Los Alamos County Community Development Department

PLANNING & ZONING COMMISSION STAFF REPORT

Subject: Sketch/Preliminary Subdivision; Case No. SUB-2025-0021

Figure 4: Proposed Replat, See Attachment A: Preliminary Plat

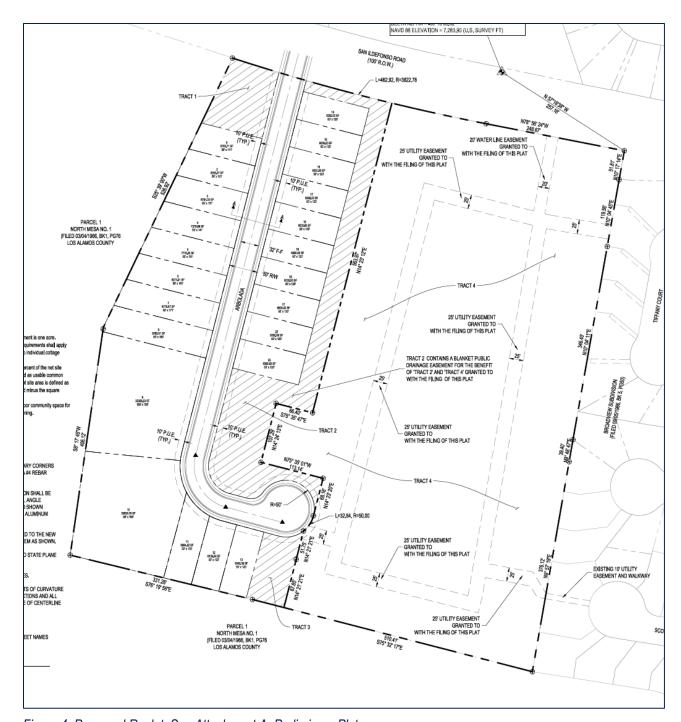
Attachment A, Preliminary Plat, presents the western portion of the development accessed by one ingress/egress from San Ildefonso Road via a 50-ft right-of-way. The street section shows a 5-ft sidewalk on both sides of the street. The street ends in a cul-de-sac between Tracts 2 and 3. There is no intent for the two developments to internally connect. Tract 4 will have its own access from San Ildefonso Road, with street designs finalized and reviewed during a Conditional Use Permit process.

Staff Response: In the staff's expert opinion, this criterion has been met because *Attachment A: Preliminary Plat* shows a 10-ft public utility easement on both sides of Arbolada Street, as well as 20–25-ft easements within Tract 4. The utility layout is further detailed in the "Overall

Utilities" plan included in *Attachment A*. Tract 2 is labeled as having a blanket public drainage easement to serve both Tract 2 and Tract 4. Additionally, the applicant has indicated in the Preliminary Plat that Tracts 1, 2, and 3 are being created for permanent open space and drainage easements. As stated by the County Engineer within Attachment B, "no features within these tracts will be accepted for County dedication or maintenance without prior approval." The Department of Public Utilities and the County Engineer have confirmed these easements meet requirements for the Sketch/Preliminary phase, but the applicant should continue coordinating with the county to finalize plans for the Final Subdivision Plat.
